Re: Florida Power & Light Company
Proposed Turkey Point Units 6 and 7
Docket Nos. 52-040 and 52-041
Response to NRC Request for Additional Information Letter No. 025 (eRAI 5414) -
Standard Review Plan Section 3.5.1.6 Aircraft Hazard

Attachment 1: FPL Response to NRC RAI No. 03.05.01.06-1 (RAI 5414)

NRC RAI Number: 03.05.01.06-1 (eRAI 5414)

Figure 1: Bearing Angle Graphical Method Verification

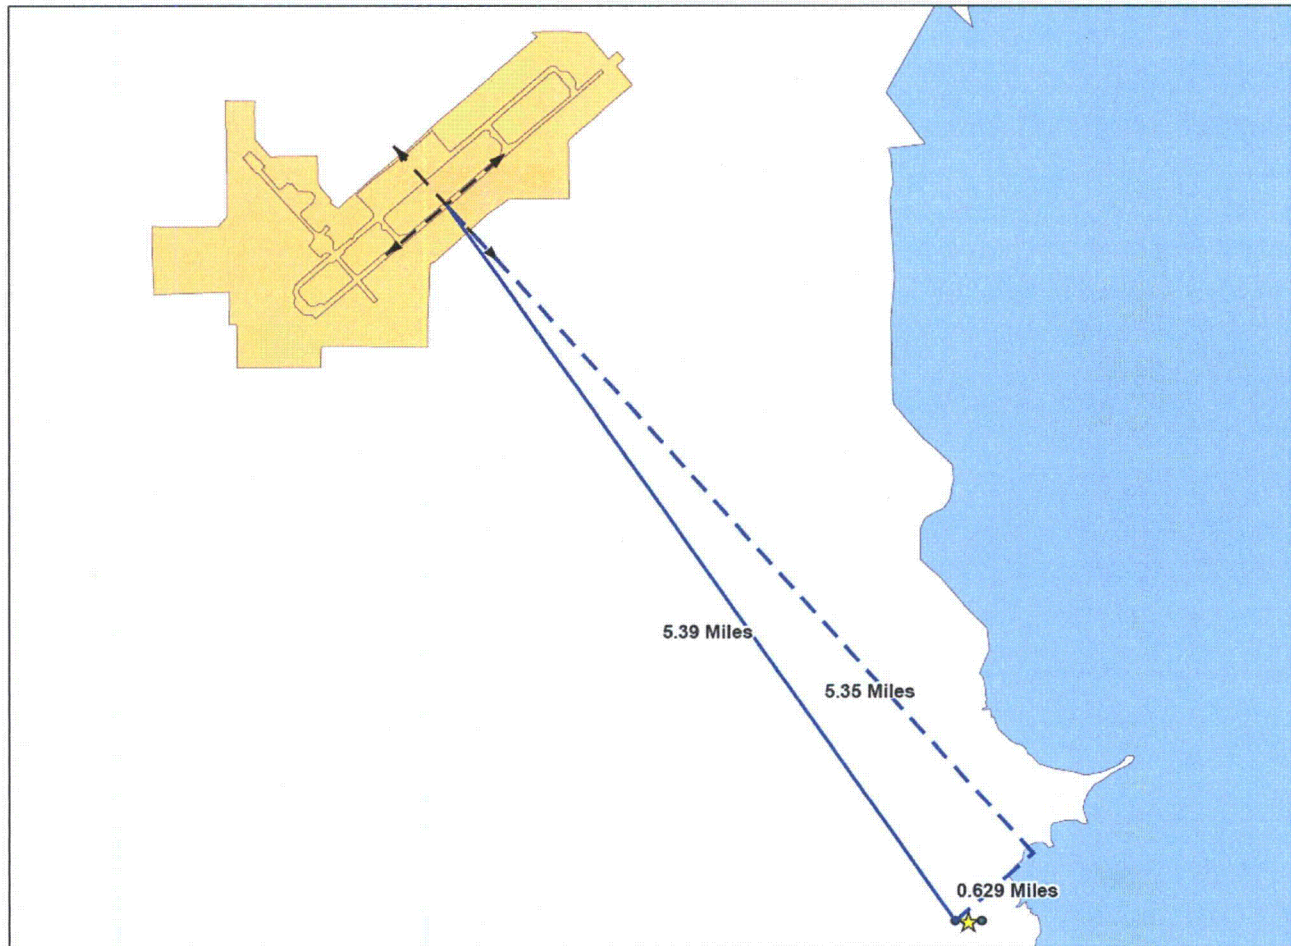
Clarify whether the total probability of 3.86×10^{-6} per year (which exceeds the acceptable probability of an order of magnitude of 10^{-7} per year) includes the probability due to flight operations at airports (2.56×10^{-7} per year) and in airway V3 (3.61×10^{-6} per year). Provide the breakdown of the flight operations used for various phases and types of aircrafts considered. Provide the calculations with the details of aircraft crash rates, the assumptions for effective areas calculations, and the parameters for aircraft crash location conditional probability (per square mile) for each aircraft type and for each flight phase used in determining this total annual aircraft crash impact probability (F).

Subsection C: Provide the calculations with the details of aircraft crash rates, the assumptions for effective areas calculations, and the parameters for aircraft crash location conditional probability (per square mile) for each aircraft type and for each flight phase used in determining this total annual aircraft crash impact probability (F).

The bearing angle, Θ , for each runway and the distance, R, from the facility to the midpoint of each runway was determined using Geographic Information System (GIS) software. The bearing angle from the facility to the midpoint of the runway was determined by measuring the angle in degrees in a clockwise direction from true north at the reference point (facility) to the straight line joining the two points together. The x and y values determined from the bearing angles and equations (5) and (6) were verified using a second graphical method presented in the DOE Standard (DOE, 2006; pp. B-37 through B-38), as depicted in Figure 1. The graphical method consists of placing the origin in the center of the runway and then drawing a line splitting the runway in half lengthwise—this represents the x-axis. Next, a line is drawn from the facility perpendicular to and intersecting the x-axis. The x and y values for Runways 05 and 23 are calculated below in Tables 3 and 4, respectively.

$x = -R \cos (\theta - \Phi)$	$y = R \sin (\theta - \Phi)$
$x = -5.38 \cos (133.3^\circ - 50^\circ)$	$y = 5.38 \sin (133.3^\circ - 50^\circ)$
$x = -0.63$	$y = 5.34$

$x = -R \cos (\theta - \Phi)$	$y = R \sin (\theta - \Phi)$
$x = -5.38 \cos (133.3^\circ - 230^\circ)$	$y = 5.38 \sin (133.3^\circ - 230^\circ)$
$x = 0.63$	$y = -5.34$
